Technical Service Information

FORD E4OD SLIPPING OR NO REVERSE AND OR NO ENGINE BRAKING IN MANUAL "2" or "1", 1990-1995

Figure 1

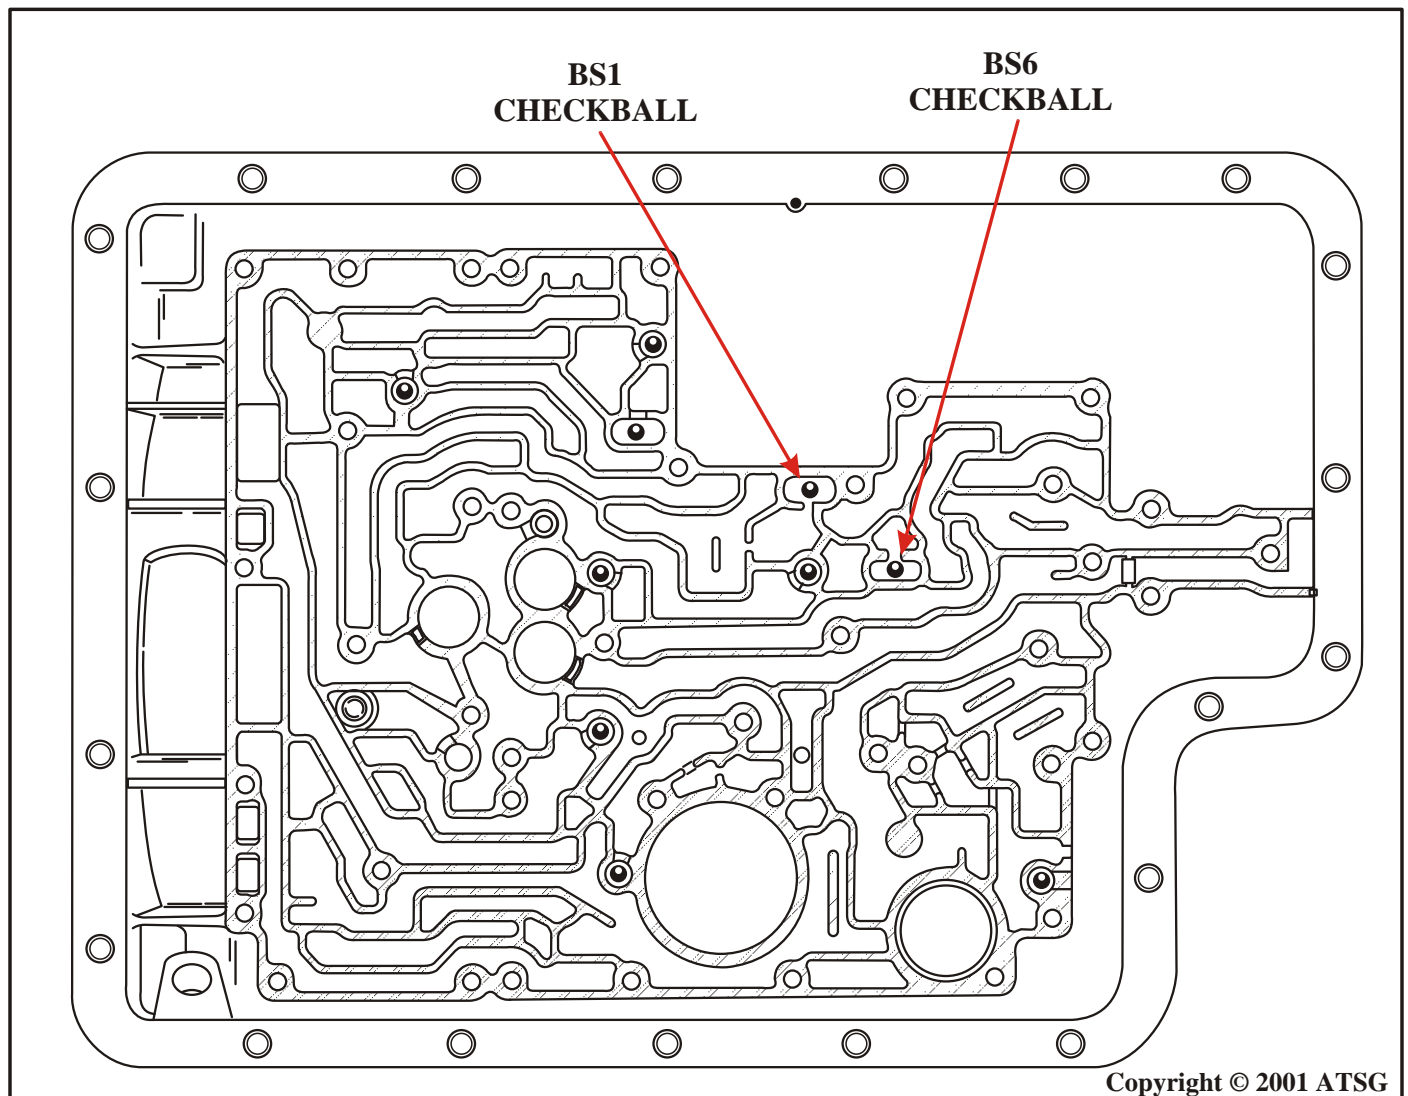
COMPLAINT: Before and/or after overhaul, 1990-1995 Ford Motor Company vehicles equipped with the E4OD transmission may exhibit a slipping or no reverse, and or no engine braking condition with the selector in the Manual 2 or Manual 1 position.

CAUSE: The cause may be a missing or misplaced BS1 or BS6 checkball. When either of these checkballs are missing, oil pressure in Reverse, Manual 2 or Manual 1 position will be exhausted at the Manual Valve.

CORRECTION: To correct this condition, install the BS1 and BS6 checkballs in the locations that are shown in Figure 1.
